# MEMORANDUM

RE: Town Park Entrance Master Plan Construction

# W.C. Construction Company, LLC

**RE:** Town Park Entrance Master Plan

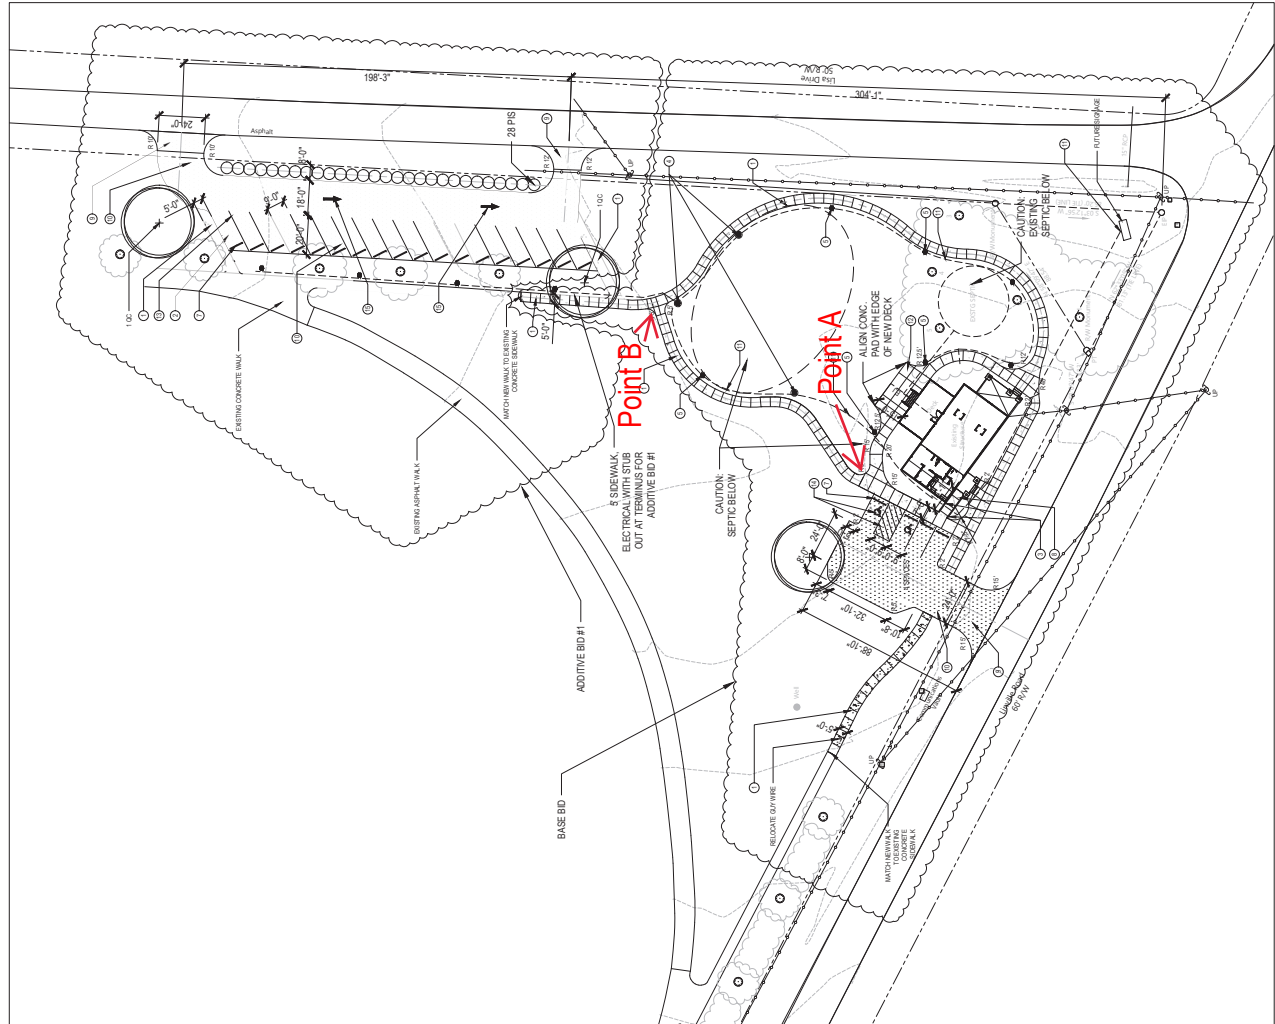
1. Full project scope including base and additive bid: \$287,000;
2. Base bid only (eliminates Lisa Dr. parking area): \$208,000
3. Value-engineered base bid, removing all electrical scope: \$163,000.
4. Value engineered base bid, removing all electrical and removing sidewalk from Point A to Point B as shown on the attached exhibit: \$157,673.

Elimination of the concrete landing area at the base of the deck was discussed but not considered, as the sidewalk would need to be redesigned to accommodate the stairs.

\$208,000.00 Original Base Bid  
\$-45,000.00 Remove All Electrical Scope Per base bid

**\$163,000.00 Total of Value Engineered Items**
